RESPONSE TO COMMENTS

Re: Sugarloaf Ridge State Park, Preliminary General Plan and
Draft Environmental Impact Report

Sugarloaf Ridge State Park General Plan – Draft Environmental Impact Report (DEIR)

**Re: Comments on Sugarloaf Ridge State Park Preliminary General
Plan and Draft EIR SCH No. 2003012051**

EXHIBIT 9-9

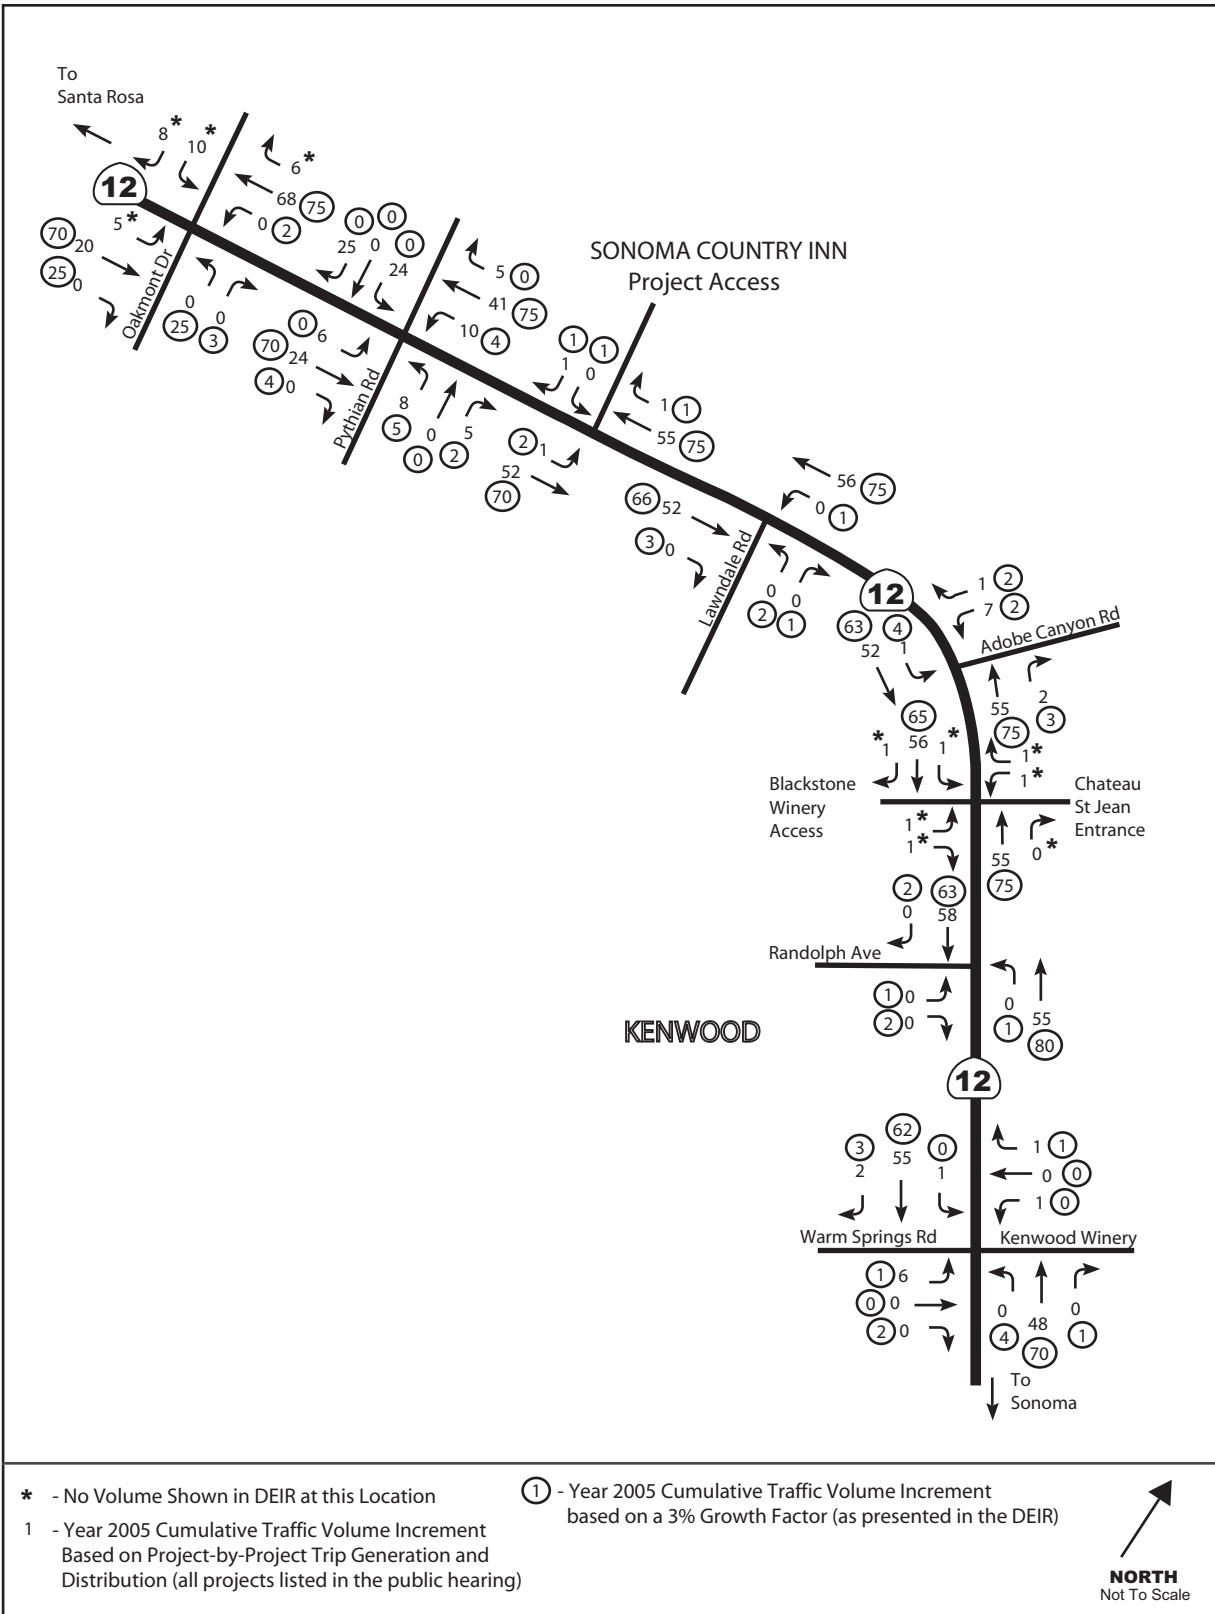
Adobe Canyon Road The Draft EIR projections for year 2012 traffic entering and exiting Adobe Canyon Road from State Route 12 are too low because the proposed expansion of Sugarloaf State Park will generate more traffic than the amount predicted by the percentage increase method used in the Draft EIR. The level of service calculations have been done again using the new projections and recalculated consistent with modeling assumptions described in Response to Comment 9-1. Exhibit 9-11 provides a comparison between years 2005 and 2012 with base case volumes determined by use of a growth rate (as presented in the Draft EIR) and on a project-by-project basis. As shown in Exhibit 9-11 for Friday PM peak hour, with either method of determining future traffic volumes the intersection level of service remains acceptable (at or better than LOS D). Based on Caltrans staff communications with PRMD staff, it is concluded that the Draft EIR overstated impacts at this intersection. See Response to Comment 9-1 for a discussion of the revised impacts at this intersection.
